River Heights City Planning Commission
Minutes of the Meeting
January 23, 2024

To: Noel Cooley, Chairman
From: Craig Rasmussen, S.E. *Craig K Rasmussen*
CC: Sheila Lind, Recorder
Date: January 22, 2024
Re: Planning Commission Submittal – Engineering Review

**CREEKSIDE ESTATES
SUBDIVISION
CONCEPT**

City Engineer Comments and Heritage Responses on Creekside Estates
January 17, 2024

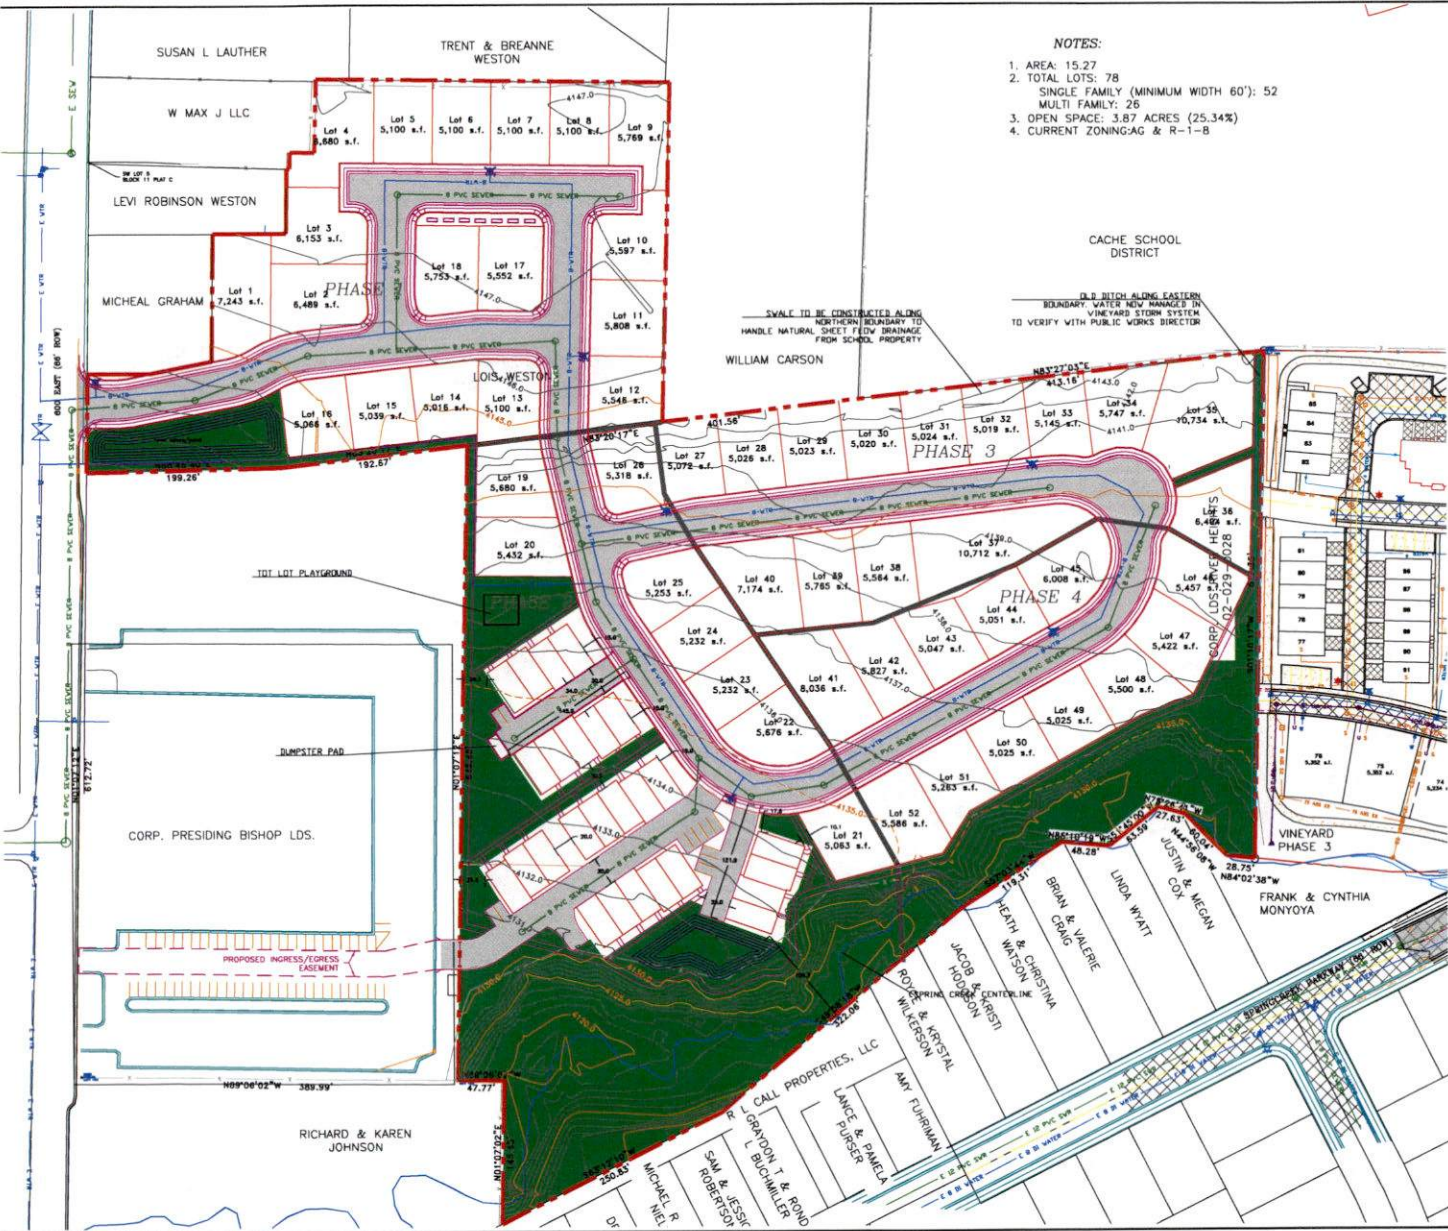
1. A Site Analysis Map has not been provided as required in Section 11-4-1 C.3. The site analysis map is important to this project for irrigation ditches, streams, wildlife habitat, flood plain, etc.

2. Per Section 11-4-1 C. 4. c. d. e. g. h. are not complete with the submittal. It is recommended that the Planning Commission take no action on advancing the Concept Plan until these items are satisfactorily addressed. However, the Planning Commission can discuss and provide comments to the developer on aspects of the Concept Plan that have been submitted.

3. Section and corporate lines should be noted on the Concept Plan as per Section 11-4-1 C. 1.
4. Following discussion with the Planning Commission, the applicant should address 11-4-1 C. m. for recommended use and reservation of open space and associated items.

5. Section 11-4-1 C. o. addresses culinary and irrigation. A discussion should be had with respect to irrigation and irrigation shares. For example, is the applicant proposing to use culinary water for irrigation of the open space? Does the applicant have irrigation shares, and will they be turned in to the City?

6. Requirements for an impact statement as specified in Section 10-10-4 A. have not been completed by the developer.
7. City has had preliminary discussion with the Cache County School District staff for looping the water line to 600 South. Updated concept plans should show the water line loop to 600 South rather than a second connection to 600 East.

8. A single dumpster location is shown for the multifamily housing. The location puts the dumpster a significant distance from the further townhomes. Recommend requiring a second dumpster location closer to the applicable units. This may change if the city requires the 20 ft separation from alley to garage as per earlier comments.

1. The developer has incorporated a look to the lots at the north end as discussed. I think this helps with plowing, but there are still two short hammer-head dead ends on the street that present plowing challenges. I understand why the developer has shown the street loop this way, they are providing frontage to lots 4 and 9. At question, will the City allow this or will the City require no hammerhead/dead end street section? Options would be to leave as-is with challenges for snow removal that certainly take additional time to plow, take out the hammerhead and provide a wider radius on the outside of the loop. With this configuration you would either loose the two lots in the corner due to not adequate frontage, or provide a frontage waiver for the lots.

2. The townhouses do not have the 20 ft setback from the alley for a driveway/parking area at each townhouse. The intent of the PUD ordinance is clear with respect to this. The developer is saying there is no lot line at the alley for a setback. The lot is the actual zero lot-line of the townhouse. In my opinion, the intent is clear in the ordinance, but wording may be able to be interpreted differently with respect to technicalities. City can require the 20 ft setback for driveway outside of garages at townhouses as per the intent of the ordinance or may exempt this. If an exemption is given, absolutely more parking is required, which will take away open space. Requiring the 20 ft setback per the ordinance will reduce the number of lots in the development, it is important to note that the City does not guarantee any number of lots – the ordinance has a maximum density, but does not state that a developer is entitled to get that density, etc.

3. Last meeting a dumpster location was discussed for the townhouses. I do not see this called out on the plan, but a white rectangle at the end of one of the alleys is shown. I wonder if this is the dumpster location? If so, it is not very centrally placed for all the townhouses and would be difficult to access for pickup.

4. Improvements to the easterly side of the single family lot loop have been made. However there is still a bulb-type street extension at lots 34, 35, and 36 that creates real snow plowing challenges. Options include leaving as is with the problems for snow plowing, leaving the property lines as is and constructing the street to a standard pavement width around the corner (taking out the bulb) and having a wider planter strip. This option cleans up the street for snow plowing and maintains frontage requirements for these three lots. It does reduce on-street parking for these lots. Another option would be to waive frontage requirements and build the standard street section with standard 3 ft park strip.

5. The plan has not been revised to show the water line loop through the school property to 600 South Street. Looping to the north is much better for water circulation for quality and quantity and provides much better redundancy for the water system in the development. Clayton has had preliminary conversation with the District and this appears to be moving forward with the District. This will either require the line to job around lot 30 or will require adjustment of parcel lines so the pipe can come straight down along the school property line without a jog in the waterline (preferred).

6. Stormwater coming through the school property has not been satisfactorily addressed. There are two items associated with this. Overland flow from the school, plans call out a swale along the northerly side of the development at the back side of lots adjoining the school. This does not address the situation – what happens to water in a swale, and property owners are not good at maintaining a swale on their lot. Second item is the large storm drain that comes through the school property. A note was added to the plan that states this may be handled on the Vineyard development and asks the City Public Works to verify. Clayton and I will review, but I expect that Heritage will need to address this stormwater conveyance.

7. A pathway was added between lots 35 and 36 as required by city ordinance. My recommendation is that the side fences along the path and rear fences along lots 35 and 36 be limited to 4 ft so the path does not feel like walking along a cattle chute. This impacts privacy on these two lots, but would certainly make for a better feel for anyone using the path.

8. Plan does not show a playground area for the townhouses.

9. There are many questions not answered or discussed yet about open space use, general amenities, and whether or not the HOA or the City will manage the open space. In my opinion, I don't see a significant benefit for the City to manage the open space. However, I do recommend that the City require that the trail/pathway through the development and paralleling Spring Creek be open to the public because a public trail along Spring Creek is on the City Master Trail Plan.

1. Heritage would prefer to keep the hammerhead turnarounds as I believe it will make plowing easier; however, if city code is provided that states we cannot do so, I will gladly change the design.

2. To us, the code is evident in the opposite of how you are interpreting the code. A setback is defined as being the distance to a property line, not to an alley. This is clearly stated in the code. As this is an item of code, I am glad to have our lawyer amicably talk with the city lawyer about the interpretation of the code. As for the parking, per Table 10-14-1-1 in River Heights City Code, 0.25 guest parking spaces are required per unit; our 12 spaces currently provided on the concept surpass this requirement.

3. The dumpster is now called out. The alley is less than 150' long and, therefore, meets the code for the garbage truck.

4. We need the bulb, as discussed in the last concept meeting. We will ensure that there is a snow easement to shove snow for the bulb to help ease the city's concerns.

5. I will show the water line on the school's property once the school has approved the connection. I request the school district provide River Heights City and Heritage with an approval letter. As I progress with each phase, we can design to each phase's requirements before construction begins.

6. The stormwater will be handled by a swale as called out in the plans; the swale will direct water to the road, to then be collected by the storm system; this will be shown in the construction drawings.

7. Thank you. I will consider this advice and discuss it with my team and engineer.

8. The playground is now shown. I'm following up with this email with the playground idea I wanted to present. Can the city let me know if they plan to take over the Park and open space?
